# Raptor Materials, LLC.

Subject: Two Rivers Sand, Gravel and Reservoir Project, File No. M-2022-013,  
112c Permit Application Adequacy Review #1 – REPLY

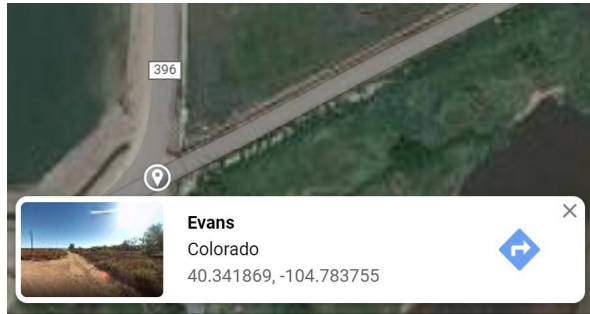
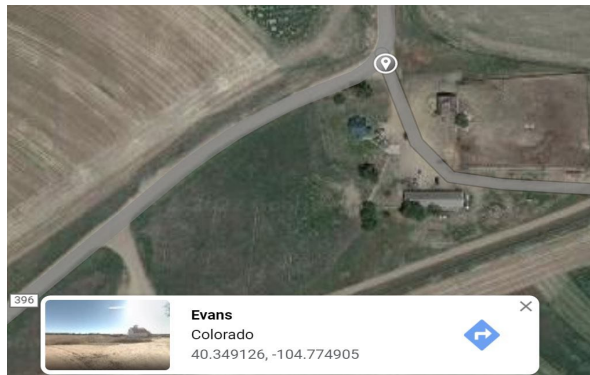
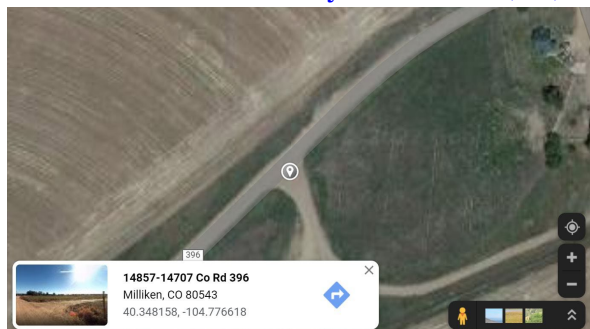
- 8) It appears that the coordinates for the Central Field SW Entrance are incorrect. Please check them and revise the Exhibit A text as necessary. (The coordinates

listed for this entrance appear to be near the Varra Coulson Project.)

Three locations were corrected as reflected in the revised Exhibit A, and verified via supporting Snippets of the coordinates captured from Google Maps, which follow, below:

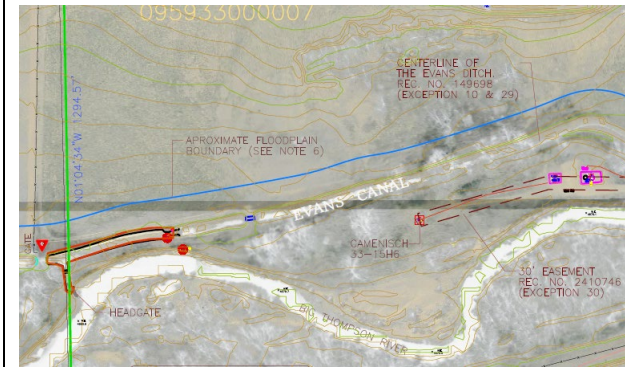
- 9) The irrigation ditches need to be clearly shown and labeled on the Existing Conditions Map (Exhibit C-1).

The Evans Ditch is labelled. The internal irrigation ditches are owned and controlled by RM, are visibly evident in the aerial image. While these company owned ditches are predominantly outside the extraction limits, some are inside the extraction limits and will be lost to extraction.

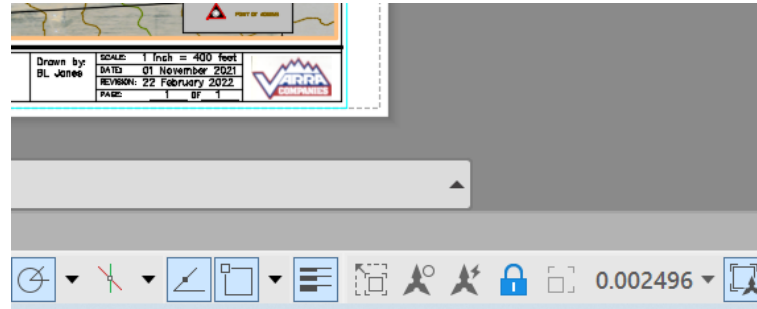
- 10) Also, per Rule 6.4.3I, the existing vegetation at the site should be shown.

Aerial images are provided to reflect a better understanding as to the nature of the diverse vegetation that either exists or could exist over the affected lands. Since it is stated that extraction occurs with the cropped lands exclusively, the denuded lands shown in the aerial image reflect the seasonal absence of crops. Crops may vary in composition from year to year, so any manifestations as to what kind of crop, if any; or the state of cover, is somewhat misleading.

Still, while we believe the aerial image satisfies the requirement, it should also be understood that this submittal is consistent with those submitted to the OMLR since 1999. We believe your colleague, Peter Hays, can attest to this.

Then (the scale reflected as indicated at 0.002496):

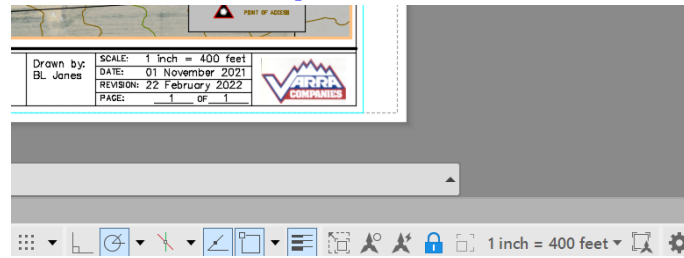
- 11) The scale on Exhibit C-1 appears to be incorrect. Please check and revise as necessary.

It was off, but so little you could just see a minor shift in the image as the Scale was remedied. A corrected version at 1" = 400' of the Original Drawing now in .pdf, is included with this submittal. Please keep in mind that in the translation of highly complicated drawings produced in Autodesk Civil 3D and Raster Design, some loss may occur as Adobe attempts to translates the .dwg files of Autodesk, into usable .pdf files necessary in communicating the OMLR permit to a diverse agency and public audience.

Now (the scale reflected as indicated at 1 inch = 400 feet – as set in Model Space).  
Note: Revised Map with corrected scale included in .pdf with this digital submittal:

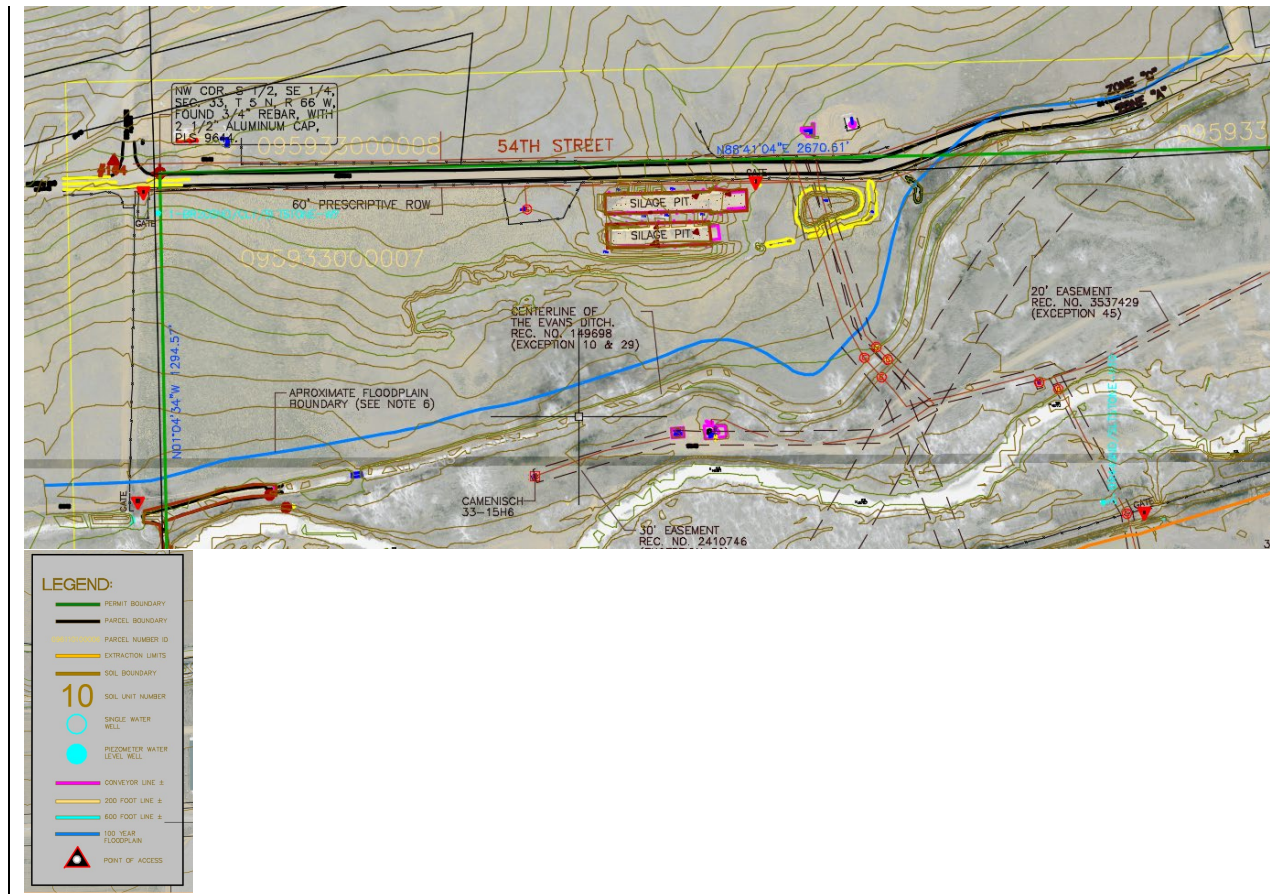
- 12) The legend on Exhibit C-1 includes the 100-year floodplain, but the floodplain lines are not on the map. These lines should be added to this map as well as the Extraction Plan Map, Exhibit C-2.

The 100-year floodplain intersects the affected lands only to the north of the Big Thompson River and can be seen in both drawings. It's clearly identified in the C-1 Legend where the 100 Year Floodplain appears in True Blue. The line remained as a reference on Exhibit C-2, but having been called out on C-1, did not appear in the C-2 Legend.

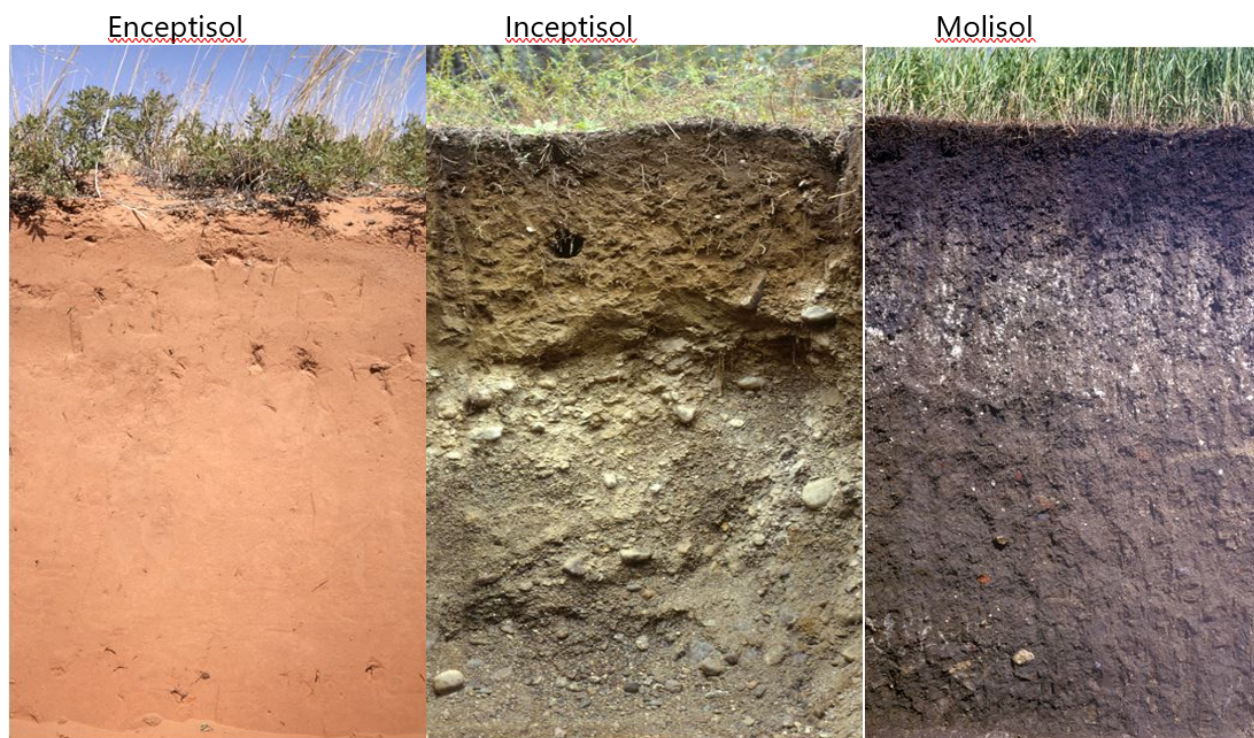
- 20) On pages 12 – 13, the discussion on stockpiles should include text indicating that soil management practices will protect the soil piles from erosion, prevent contamination of the soil from toxic or acid-forming material, and ensure that the soil will remain usable for reclamation.

Comments 20, 23 and 32 we believe are best addressed in a comprehensive rather than fragmented manner.

Consistent with the backfill permit, it would be highly unusual that an alluvial aggregate operation would find potentially toxic or acid forming materials, nor would they if found be utilized. Sulfur is sometimes used on plains soils where acidification moderates alkalinity or the planting of evergreen trees which prefer a slightly acidic soil. Nonetheless the Operator's intent is not to create or import such a problem. If found on site such materials would be disposed of in an appropriate landfill. The application does attend to the real threat on irrigated lands, which is the accumulation of salts due to evapotranspiration in some circumstances of the lower soil profile, which profile is significantly absent in Unit 3 Soils, as iterated here:

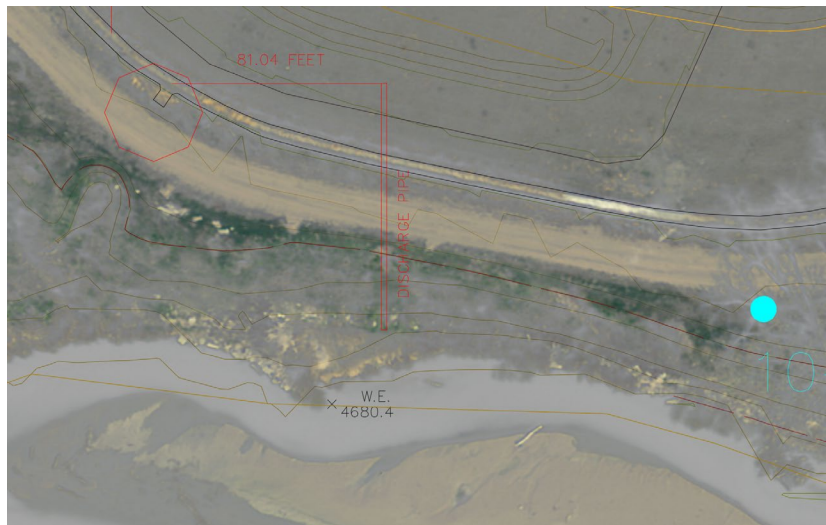
- 44) Describe the physical dewatering system and provide a description of the operation of this system.

A copy of the discharge permit application provided to CDH is included with this submittal. It will indicate information about the pump capacity and discharge rates. Exhibit D: Extraction Plan devoted a section to it, and AWES devoted a report to it, as provided with the other attachments in this reply. Here’s what the permit application stated, followed by a blow-up of the feature visible near the #10 Piezometer, under Exhibit G: Water Information Map:
